Subject: N242450210 - Service Update
Incorrect Outside Rearview Mirror Torque

Models: 2024 Chevrolet Blazer
2024 Chevrolet Blazer EV

N242450210 Incorrect Outside Rearview Mirror Torque

5132480

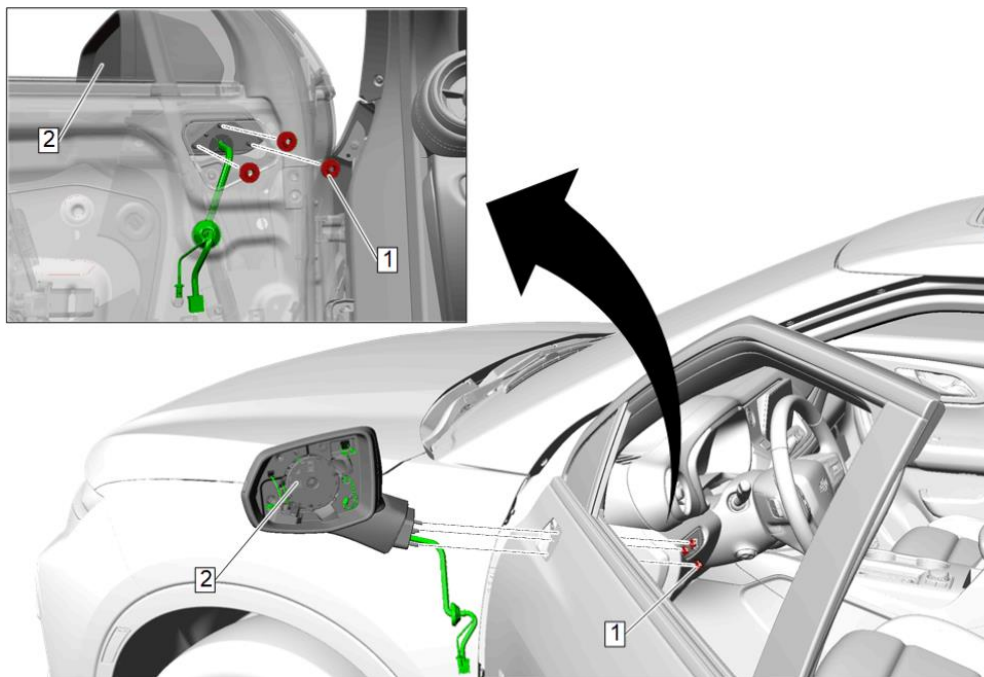
Condition	Certain 2024 model year Chevrolet Blazer and Blazer EV vehicles may have a condition in which the fasteners on the driver's side Outside Rearview mirror are incorrectly torqued.
Correction	Dealers will fasten the driver's OSRV mirror to the design torque specification.

3. Tighten the Outside Rearview Mirror Fasteners to 9 N•m (80 lb in)
